Project	<b>IEEE 802.16 Broadband Wireless Access Working Group</b> < <a href="http://ieee802.org/16">http://ieee802.org/16</a> >	
Title	<b>Complementary document for draft comments</b>	
Date Submitted	<b>2004-01-13</b>	
Source(s)	Yossi Segal Itzik Kitroser Yigal Leiba Zion Hadad Runcom Technologies Ltd. 2 Hachoma St. 75655 Rishon Lezion, Israel	Voice: +972-3-9528440 Fax: +972-3-9528805 <a href="mailto:yossis@runcom.co.il">yossis@runcom.co.il</a> <a href="mailto:itzikk@runcom.co.il">itzikk@runcom.co.il</a> <a href="mailto:yigall@runcom.co.il">yigall@runcom.co.il</a> <a href="mailto:zionh@runcom.co.il">zionh@runcom.co.il</a>
Re:	Contribution elaborating on comments for letter ballot #13a	
Abstract	This document includes text referenced in several comments given for ballot 13a	
Purpose	To be integrated into P80216-REVd_D2 document	
Notice	This document has been prepared to assist IEEE 802.16. It is offered as a basis for discussion and is not binding on the contributing individual(s) or organization(s). The material in this document is subject to change in form and content after further study. The contributor(s) reserve(s) the right to add, amend or withdraw material contained herein.

**Figure 214—DL Frame Prefix sub-channel allocation for segment 1 using FUSC**

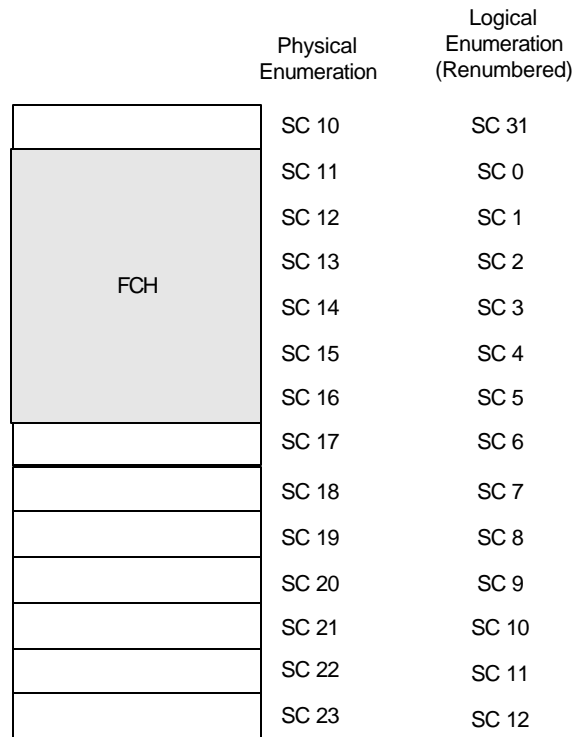
In FUSC, the first 642 transmitted subchannels in the first data symbol of the downlink contains the FCH as defined in 8.4.4.2 (using QPSK rate 1/2 and repetition coding of 64), for any segment the first 6 sub-channels of the segment shall Subchannels 0-11 contain the FCH. Figure 214 depicts this structure:

Figure 230a— Example of using FHDC in OFDMA

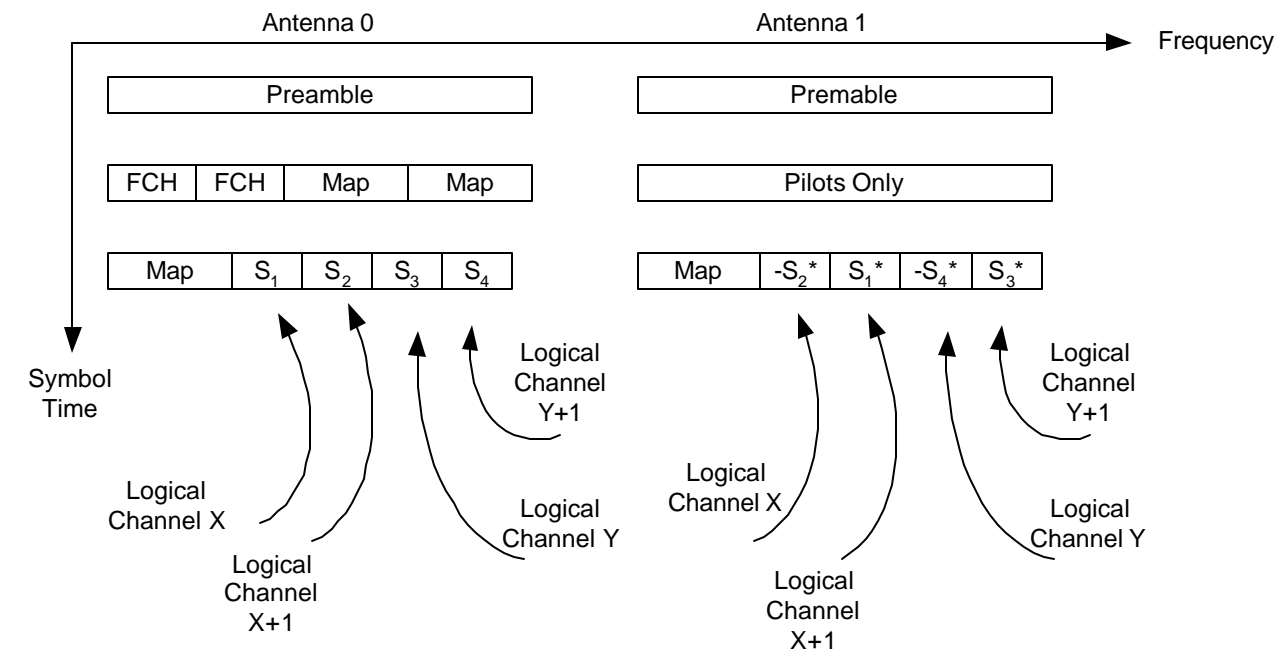
The downlink shall enable the co-transmission of regular Subchannel transmission and FHDC Subchannel transmission as explained in 8.4.8. The minimal allocation of subchannels for a segment (if the segment is used) is 5 subchannels (and shall follow section 8.4.4.5), when FHDC is used then the encoding of the DL-MAP shall also be performed using the same repetition rate as the FCH (this is done to enable the adequate reception of the FCH and the DL-MAP by Transmit diversity users, as well as regular users). The DL-MAP shall define the combined FHDC and regular transmission allocations, regular allocations shall be transmitted from antenna 0 only, while STC allocations shall be transmitted from both antennas (in any case antenna 1 shall always transmit in this combined mode of operation at least the pilot-sets allocated for it) Figure 230a shows an example of FHDC usage for OFDMA.

Figure 230b— Illustration of Transmit diversity using 4 antennas

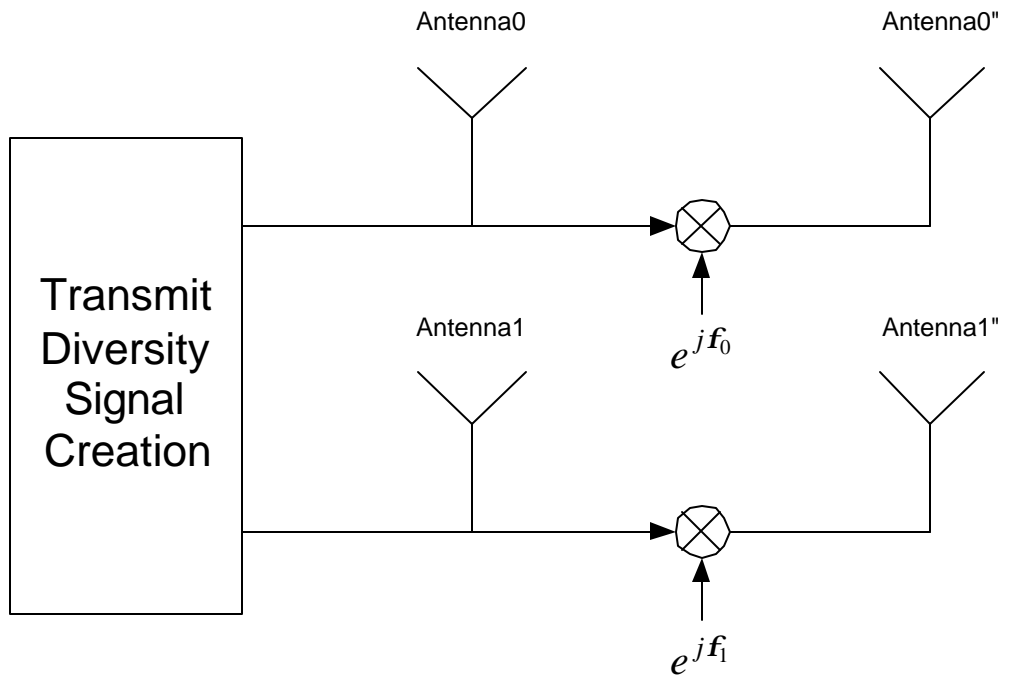
The Transmit diversity schemes could be further enhanced by using 4 antennas at the transmission site. Two antennas are now being used in order to transmit each symbol (the first antenna transmits the signal as defined in 8.4.8.2 and 8.4.8.3, and the second transmits the same signal with a complex vector rotation), this transmission shall create additional multipaths received by the user, these multipaths aim are to reduce the effect of the Rayleigh channel variation. This method gives the space diversity associated with the STC/FHDC with an additional multipath creation caused by another antenna; this scheme is presented in figure 230b:
